YANKEE ATOMIC ELECTRIC COMPANY

February 25, 1994
FYC 94-003
SPS 94-015

Subject: Comment on NUREG-1488, "Revised Livermore Seismic Hazard Estimates for 69 Nuclear Power Plant Sites East of the Rocky Mountains," dated October, 1993

FIGURE 1

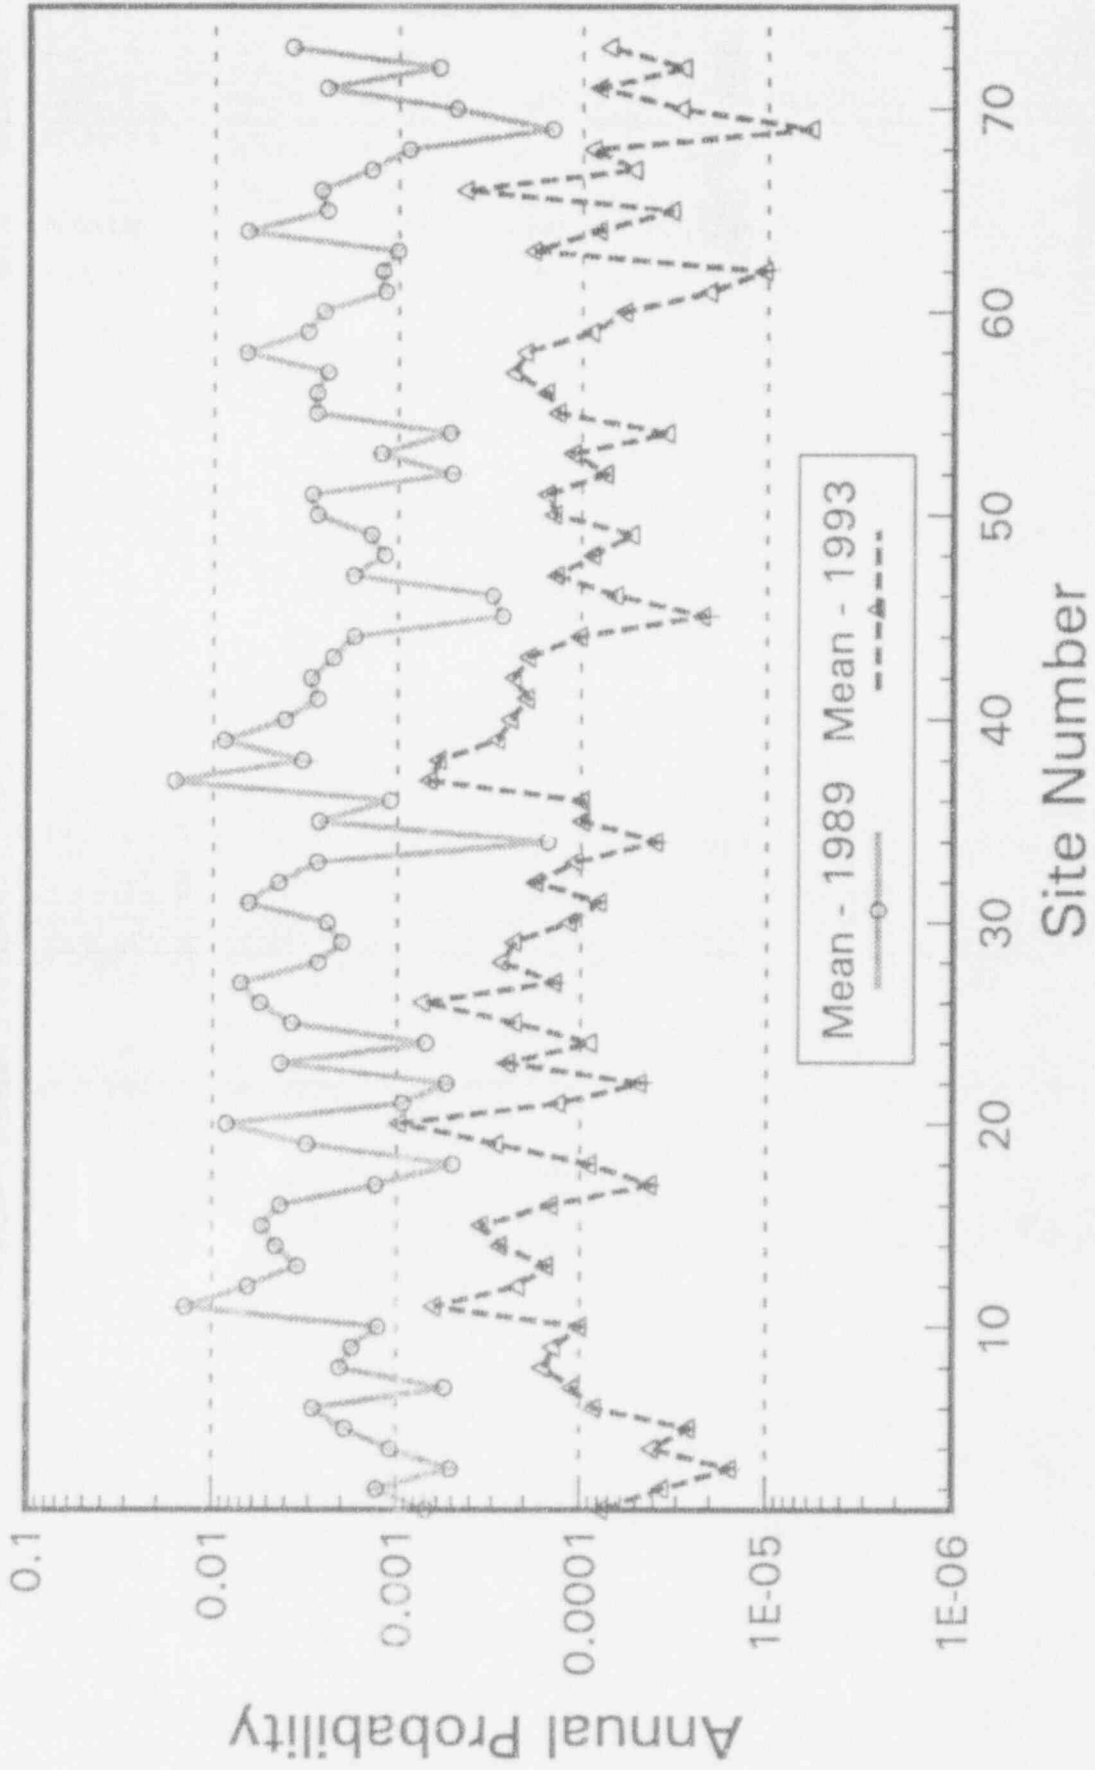
We believe these revised LLNL results represent significant new information that should not only be used in the review of Individual Plant Examinations of External Events (IPEEE) submittals, and early site reviews, but, most importantly, in a timely review of the level of effort required by each utility for the seismic portion of IPEEE. Given these improved 1993 LLNL results, it can be shown that the seismic hazard at existing EUS nuclear power plants is much less than what originally had been

believed (see Figure 1 attached). To date, however, this drastic reduction in the LLNL seismic hazard estimates has not been accompanied by a reduction in either Staff review effort or reductions in NRC mandated programs which have their basis in the early LLNL estimates of the seismic hazard.

FIGURE 2

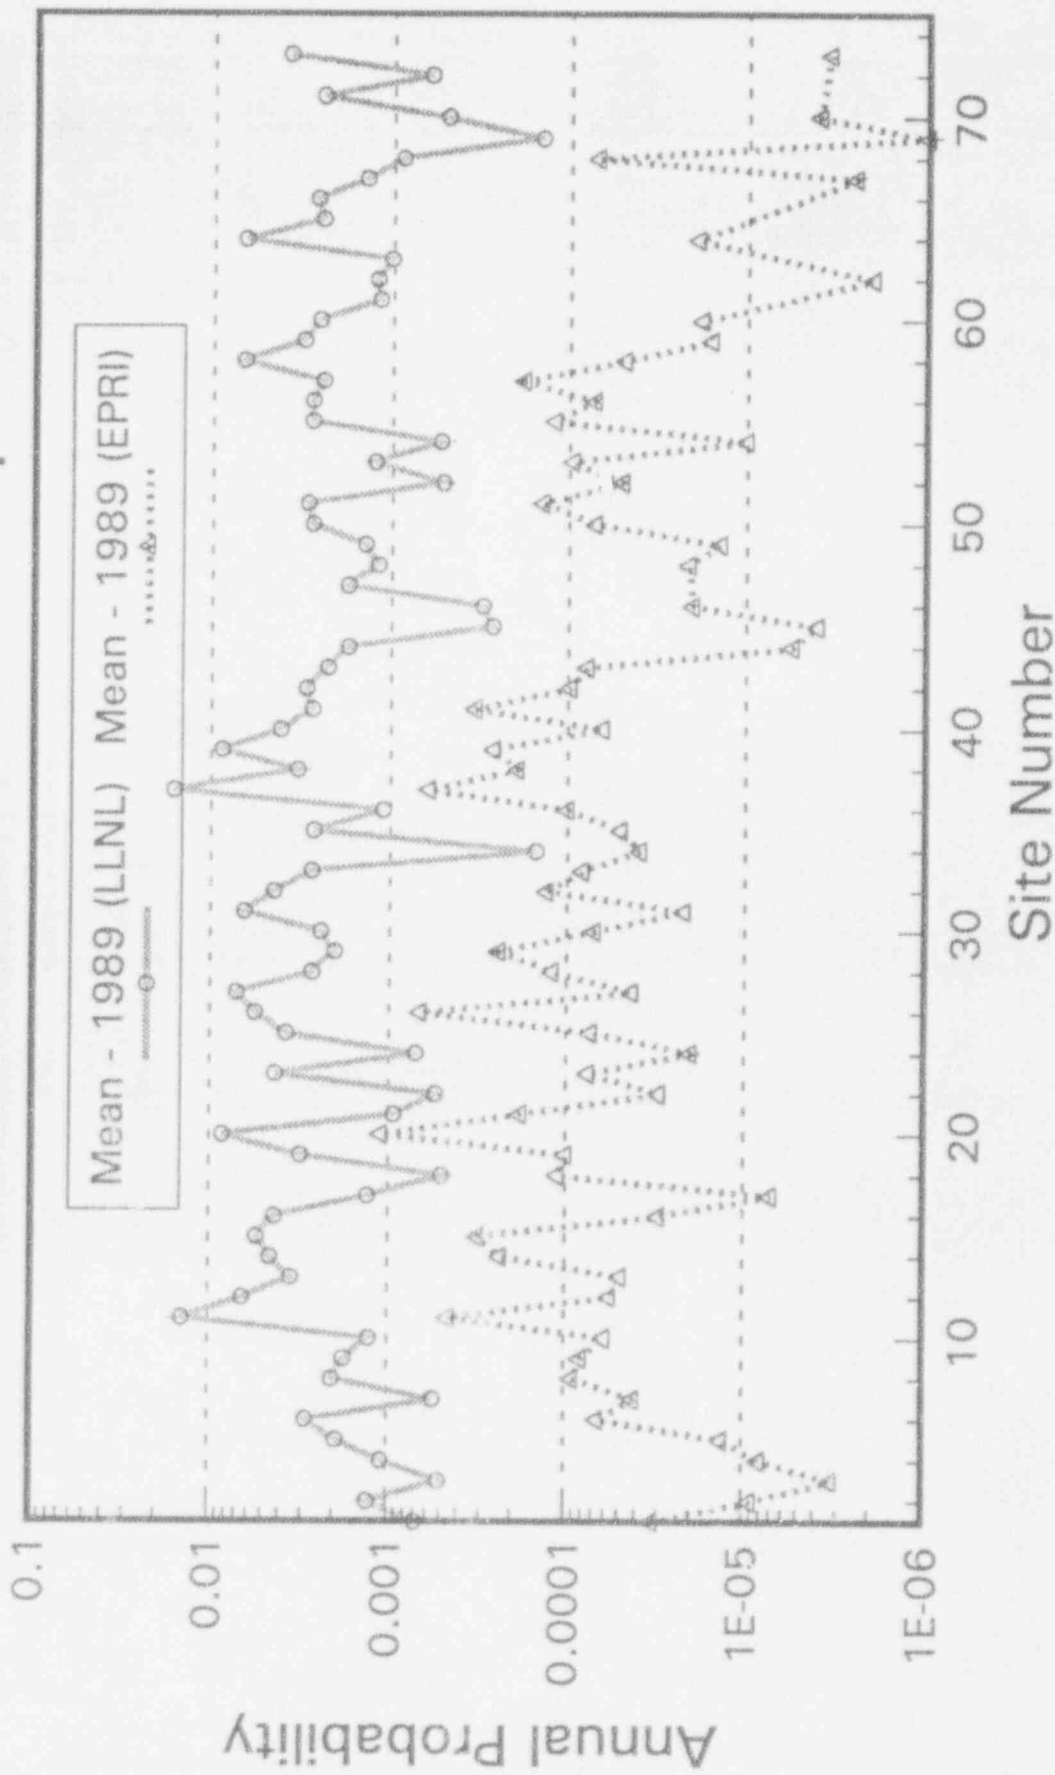
Figure 2 (attached) compares the probability of exceeding the SSE at all EUS sites based upon the 1989 LLNL (NUREG\CR-5250) and 1989 EPRI results (EPRI NP-6395-D). As can be seen, the LLNL results are much higher in probability than the EPRI results. This large difference in seismic hazard estimates led to the NRC use of relative rankings in the IPEEE binning process. Figure 3 (attached) is a similar comparison to Figure 2, except now the 1993 LLNL results are used. The detailed issues mentioned above notwithstanding, we believe that these latest (NUREG-1488) results confirm the validity of the 1989 EPRI seismic hazard analyses.
